Access Compliance Report

Public Rights-of-Way

Intersection ID: 16587	Main Street: NORTH_FALLS_DR	Cross Street: W_TYVOLA_RD	Location: NE
ADA ID: 0F72BA075678	Ramp Type: PerpDiag	Initial Pass/Fail: Fail	Overall Compliance: No
Severity Score: 12.5			
Codes/Mitigation Info/Possible Solution		Field Measurements/Component Compliance

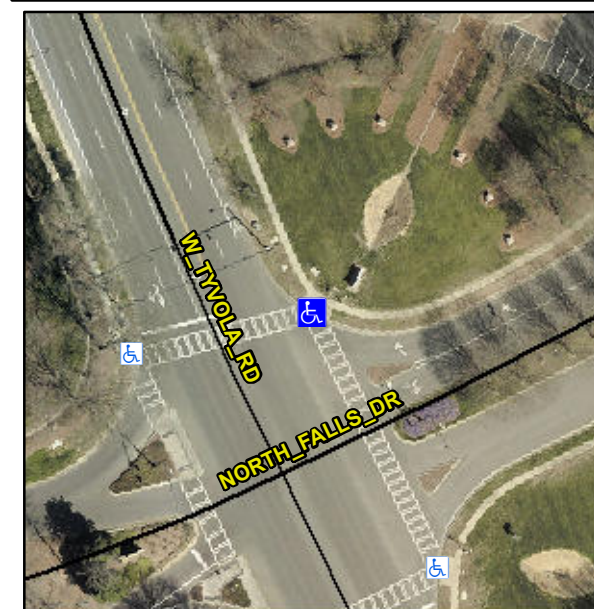
Not Found, R304.5.3

Compliance	Description	Data	Compliance	Description	Data
N/A	Ramp Length (in)	125.0	Yes	Ramp Slope (%)	6.5
Yes	Ramp Width (in)	63.0	No	Ramp XSlope (%)	6.8
N/A	Flare Type LT	N/A	N/A	Flare Type RT	N/A
N/A	Flare Slope LT (%)	N/A	N/A	Flare Slope RT (%)	N/A
N/A	Flare Traversable LT?	N/A	N/A	Flare Traversable RT?	N/A
N/A	Landing Length (in)	N/A	N/A	DWS Provided?	N/A
N/A	Landing Width (in)	N/A	N/A	DWS Contrast?	N/A
N/A	Landing Slope (%)	N/A	N/A	DWS Length (in)	N/A
N/A	Landing X Slope (%)	N/A	N/A	DWS Full Width?	N/A
N/A	Landing Curb? (Y/N)	N/A	N/A	DWS Offset (in)	N/A
N/A	Shared Landing?	N/A			
N/A	Gutter Ponding?	N/A	N/A	Gutter Slope (%)	N/A
N/A	Gutter Lip Ht (in)	N/A	N/A	Gutter X Slope (%)	N/A
N/A	Painted X Walk1?	Yes	N/A	Painted X Walk2?	Yes
	X Walk 1 Direction	To W		X Walk 2 Direction	To S
N/A	X Walk 1 Width (in)	112.0	N/A	X Walk 2 Width (in)	107.0
	X Walk 1 Slope (%)	2.7		X Walk 2 Slope (%)	3.5
	X Walk 1 X Slope (%)	3.3		X Walk 2 X Slope (%)	3.3

Remove & Replace Curb Ramp With Two New Directional Ramps or Equivalent.
